**Feasibility Study Monitoring Well Installation Plan  
for RVAAP-66 Facility-wide Groundwater**

**Former Ravenna Army Ammunition Plant  
Portage and Trumbull Counties, Ohio**

Appendix A.	Ohio EPA Comments
-------------	-------------------

**Subject: Response to Ohio EPA Comments on the "Draft RVAAP-66 Facility-wide Groundwater, Feasibility Study Monitoring Well Installation Plan" dated September 20, 2022**

Figure 2-1. RVAAP-05 Winklepeck Burning Grounds – COC Groundwater Concentrations

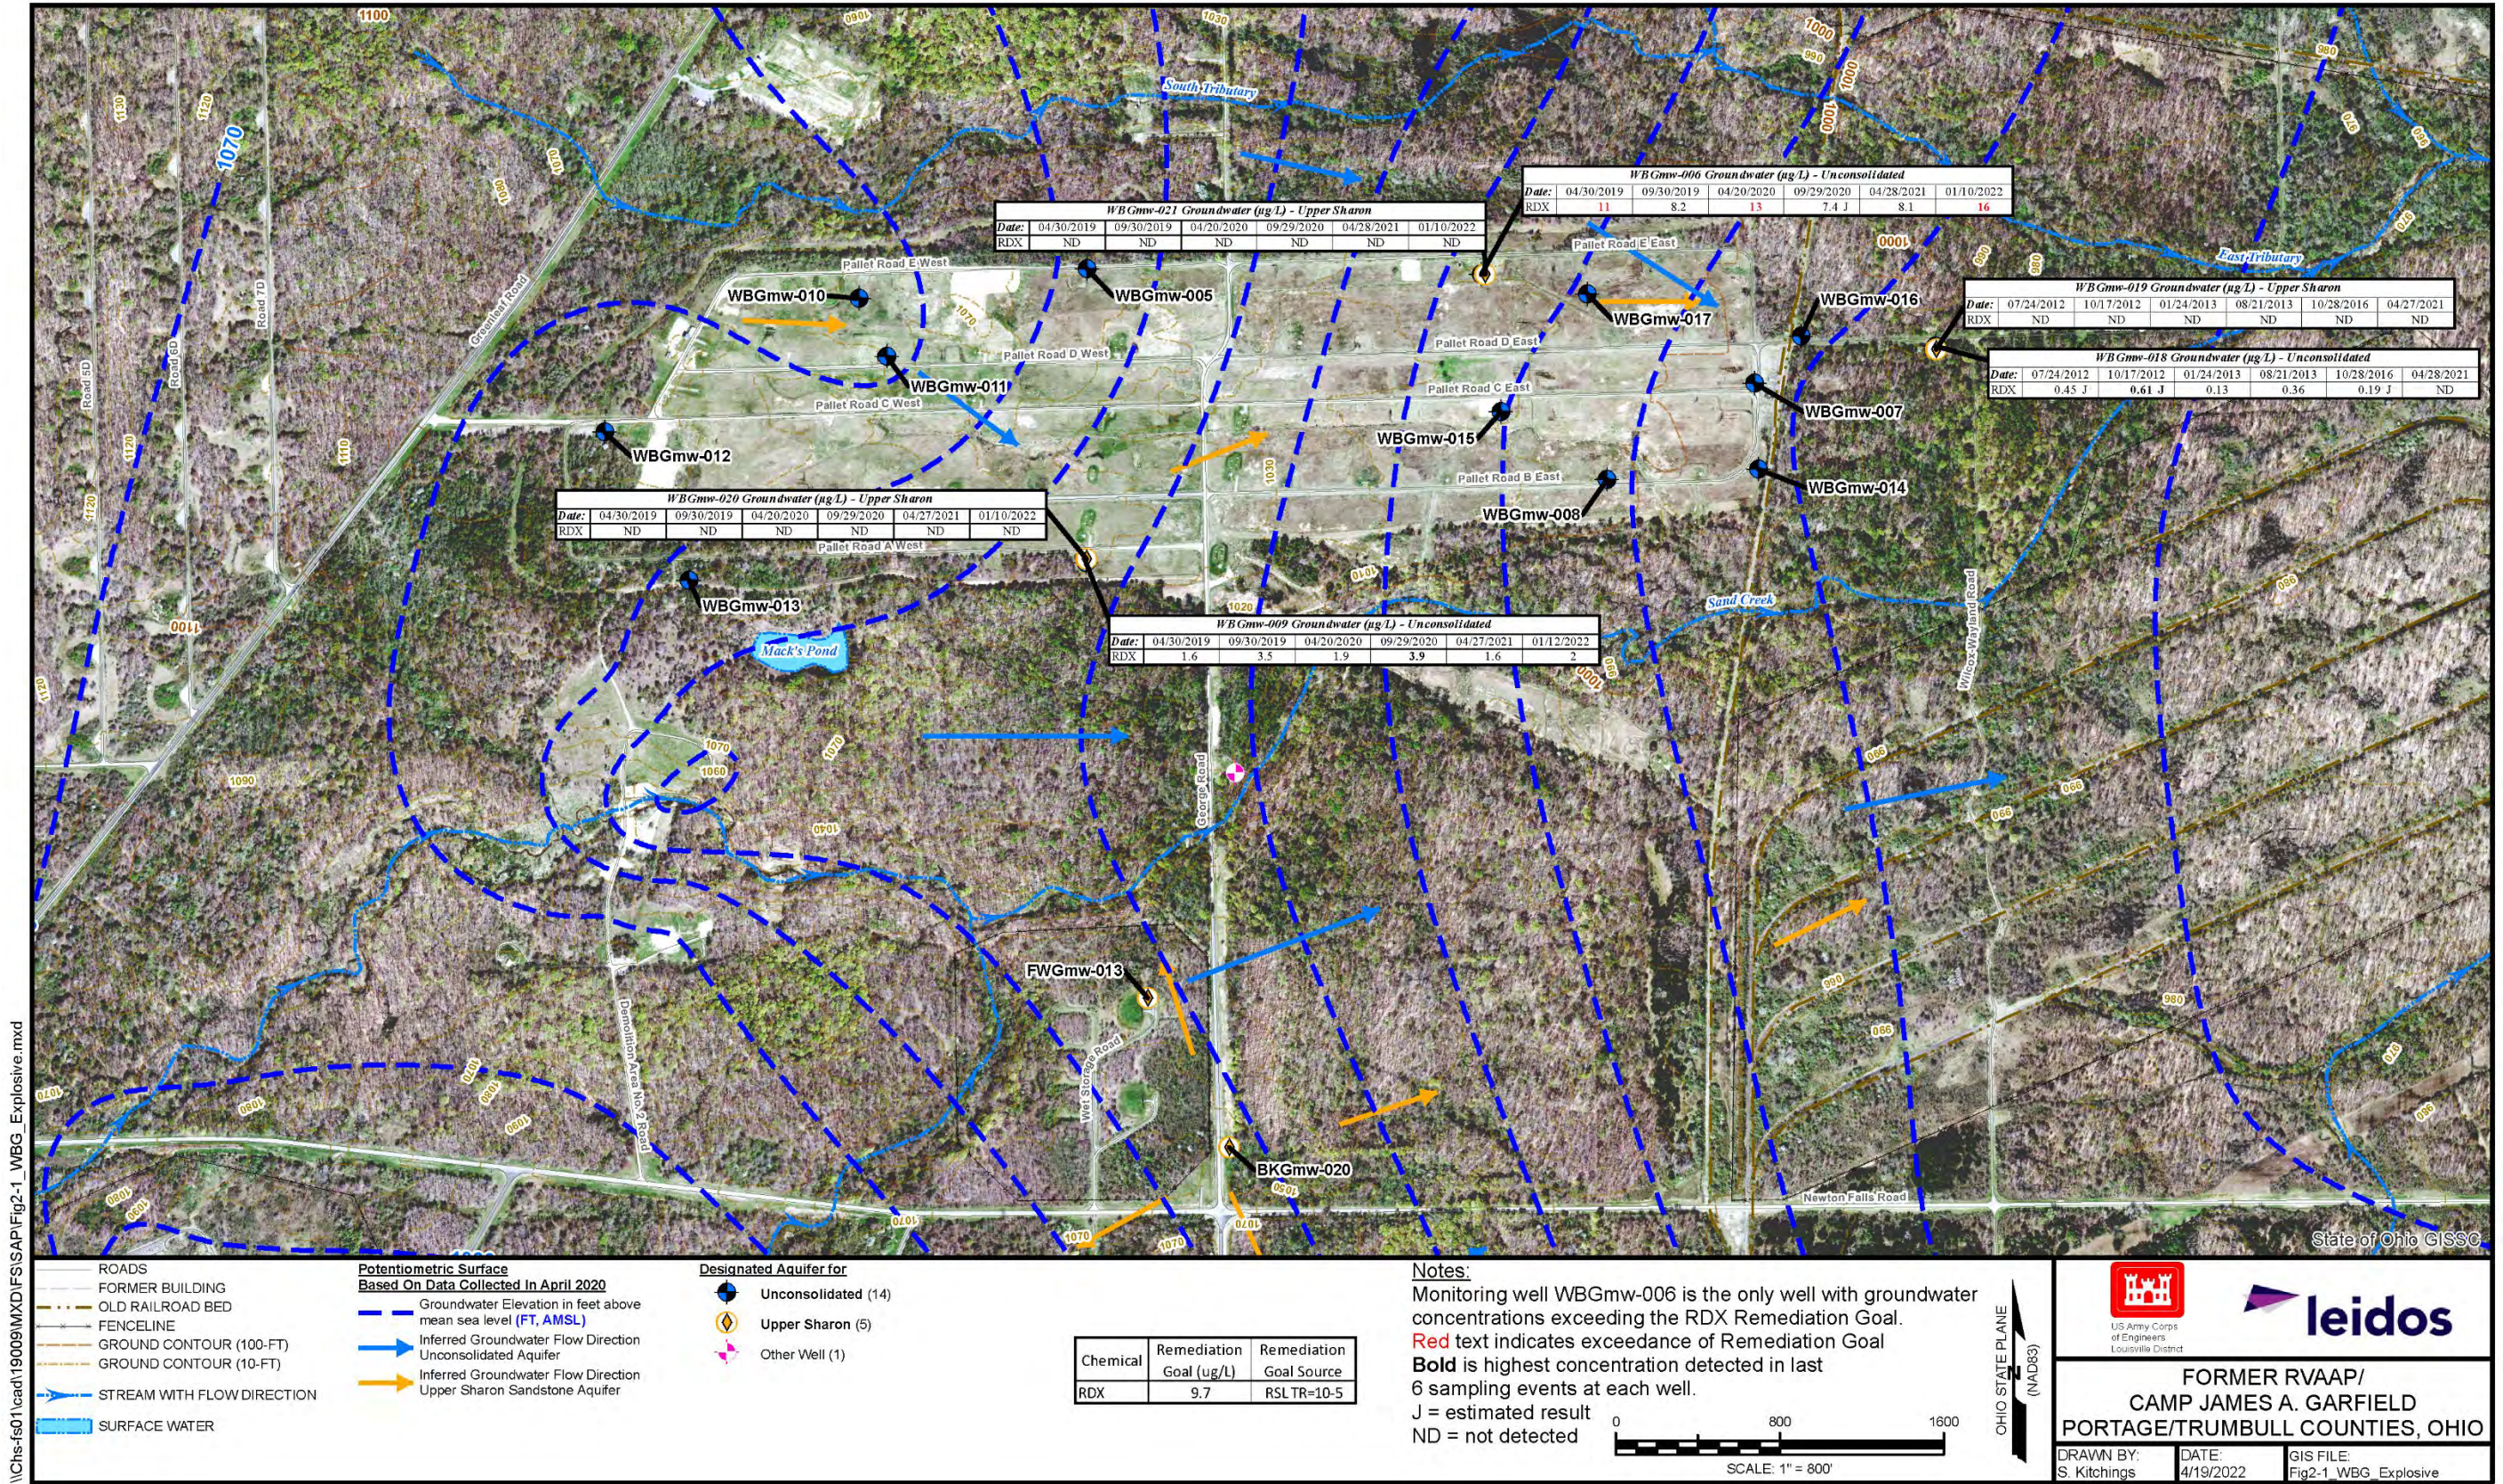
Ohio EPA concurs with the further evaluation in an FS for potential remediation of 1,3,5- trinitro-1,3,5-triazine (RDX) in the Unconsolidated aquifer of Winklepeck Burning Grounds (around WBGmw-006 and WBGmw-009) as recommended above. Ohio EPA has previously concurred with the statement that “no additional wells are required to develop an FS for the site”, but requests clarification since previous United States Army Corps of Engineers (USACE) response was that “During the development and regulatory review of the FS, it will be determined if additional wells are needed to refine the conceptual site model and/or monitor contaminant migration.” (January 29, 2021, Responses to Comments on the Draft Remedial Investigation Report for RVAAP-66 Facility-wide Groundwater (January 2021 Draft RI RTC Letter)). Ohio EPA wants to clarify that additional wells, if warranted, will still be installed in the future.

Ohio EPA concurs with the further evaluation in an FS for potential remediation of 1,3,5-trinitro-1,3,5-triazine (RDX) in the Unconsolidated aquifer of Winklepeck Burning Grounds (around WBGmw-006 and WBGmw-009) as recommended above. Ohio EPA has previously concurred with the statement that “no additional wells are required to develop an FS for the site”, but requests clarification since previous United States Army Corps of Engineers (USACE) response was that “During the development and regulatory review of the FS, it will be determined if additional wells are needed to refine the conceptual site model and/or monitor contaminant migration.” (January 29, 2021, Responses to Comments on the Draft Remedial Investigation Report for RVAAP-66 Facility-wide Groundwater (January 2021 Draft RI RTC Letter)). Ohio EPA wants to clarify that additional wells, if warranted, will still be installed in the future.

Army Response: The conceptual site model (CSM) is in development for the FS to provide the most recent available data and remediation goals. As shown in Figure 2-1, there are several wells in the unconsolidated aquifer located downgradient of the COC exceedances as well as deeper wells in the Upper Sharon which will provide for a refined CSM in the FS. It is unlikely that additional wells will be required; however, this determination will be completed as part of the CERCLA process in subsequent decision documents.

Figure 2-2. RVAAP-08 Load Line 1 Feasibility Study Well Locations

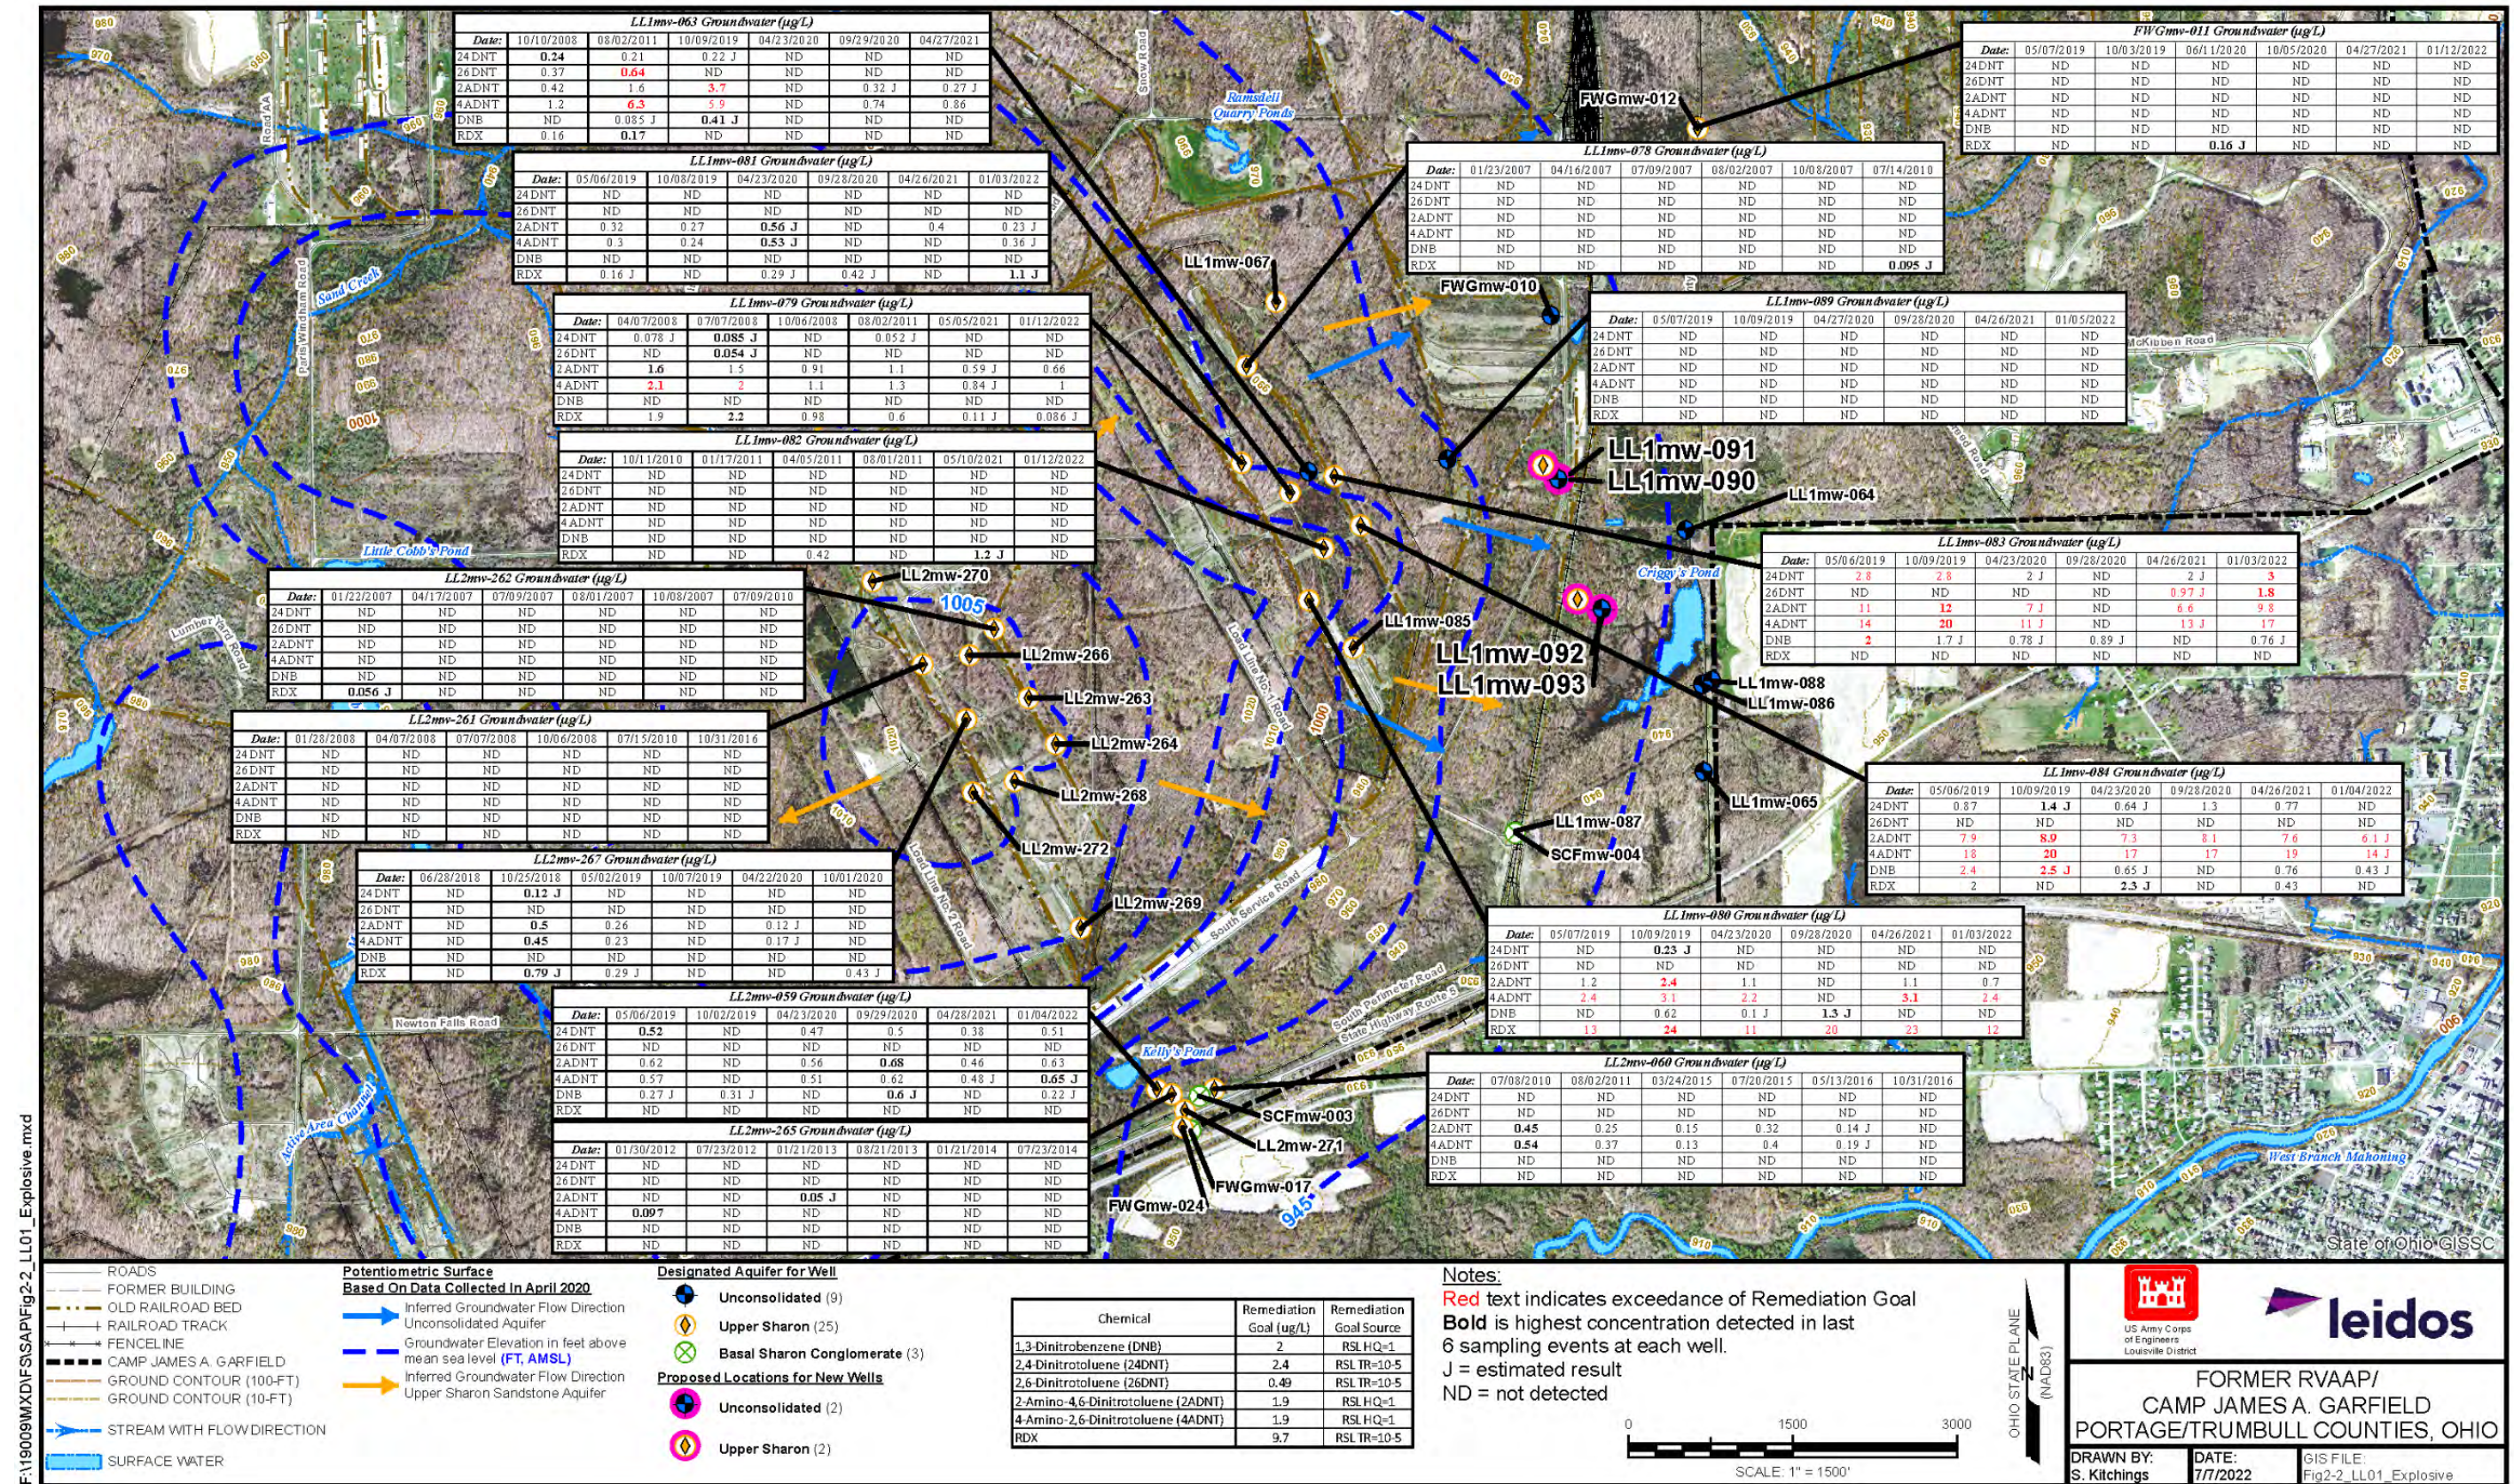
Ohio EPA concurs with the proposed installation of four monitoring wells (two well pairs) to be installed east of Load Line 1 in order to supplement the FS and concurs with the proposed locations as denoted on Figure 2-2 of the Draft FS Additional Well Install Plan 2022. The proposed 15 to 30 feet below ground surface (bgs) well screen interval for the Unconsolidated aquifer wells appears acceptable, but further clarification is requested for the proposed Upper Sharon aquifer screening levels of approximately 70 to 90 feet bgs. Nearby Upper Sharon wells LL1mw-082, 83, and 84 are all approximately 40 feet in depth; please clarify why 70-90 feet depths will be appropriate for Upper Sharon wells.

Ohio EPA concurs with the proposed installation of four monitoring wells (two well pairs) to be installed east of Load Line 1 in order to supplement the FS and concurs with the proposed locations as denoted on Figure 2-2 of the Draft FS Additional Well Install Plan 2022. The proposed 15 to 30 feet below ground surface (bgs) well screen interval for the Unconsolidated

aquifer wells appears acceptable, but further clarification is requested for the proposed Upper Sharon aquifer screening levels of approximately 70 to 90 feet bgs. Nearby Upper Sharon wells LL1mw-082, 83, and 84 are all approximately 40 feet in depth; please clarify why 70-90 feet depths will be appropriate for Upper Sharon wells.

In preliminary cross-sections developed for the FS, both ground elevation and the bedrock plane from Load Line 1 dips dramatically to the east and southeast. Furthermore, the unconsolidated aquifer is thicker to the east at Criggy's Pond. Thus, in order to capture the appropriate depth for groundwater in both the unconsolidated and Upper Sharon, the elevation of the wells must be determined by depth to bedrock rather than ground surface. At FW-011 and FW-012, bedrock was encountered at 920 ft amsl. At LL1mw-086 and LL1mw-088, bedrock was encountered at 860 ft amsl. Table 2-1 provides the ground elevation and rationale for depths in both feet below ground surface (bgs) and elevation above mean sea level (amsl). Actual depth to bedrock and well screen interval will be field determined but may occur at any depth between 920-860 ft amsl, therefore the new Upper Sharon wells will be screened within the shallow water bearing zone of the bedrock aquifer. The text in Section 2.2 will be revised as follows:
